**From:** Tony Symonds <[REDACTED]>  
**Sent:** 04 June 2021 10:31  
**To:** Stephen Reed <[Stephen.Reed@westsussex.gov.uk](mailto:Stephen.Reed@westsussex.gov.uk)>  
**Subject:** FW: A29 - WSCC Planners Drainage Comments

WSCC Comment	Response	
<p>2.1 Overland flow routes were identified as a potential flood risk issue as part of the design process (paragraph 6.2.9 of Appendix 11.1).</p> <p><i>At the Barnham Road tie-in, the existing road is very flat to the west of the proposed roundabout where it has been indicated that some overland flow may be occurring. With our proposed alignment of roundabout raising the carriageway level there is a risk that an existing flooding issues may be exacerbated. We therefore propose to provide extra gullies at the low point, these will connect to the existing highway drainage.</i></p> <p>In addition, two CCTV condition surveys were carried out along Barnham Road to confirm the final road</p>	<p>The section to the west of the rbt provides a combined drainage kerb system on both sides of the channel lines discharging to the proposed separate highway drainage system. The low point at 10.72m has been removed with the rbt vertical alignment.</p> <p>The

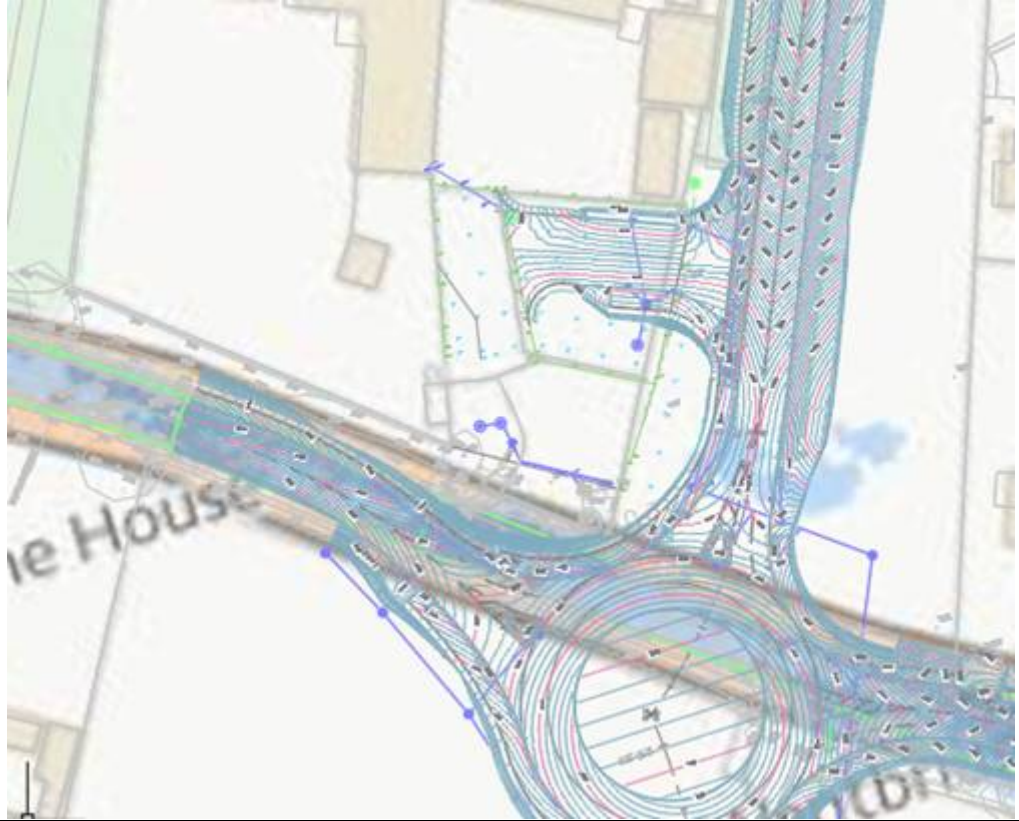
design/mitigation measures at the proposed roundabout with Barnham Road (para 6.2.11 and Appendix D). The surveys identified issues in the pipe work and the need for further works noting that *if the faults of and the obstruction in the pipes are not fixed then this will be a potential flood risk issue* (para 6.2.15). A number of grade 5 defects requiring urgent action to prevent total failure

determine the repair works to be undertaken as a separate package of works.
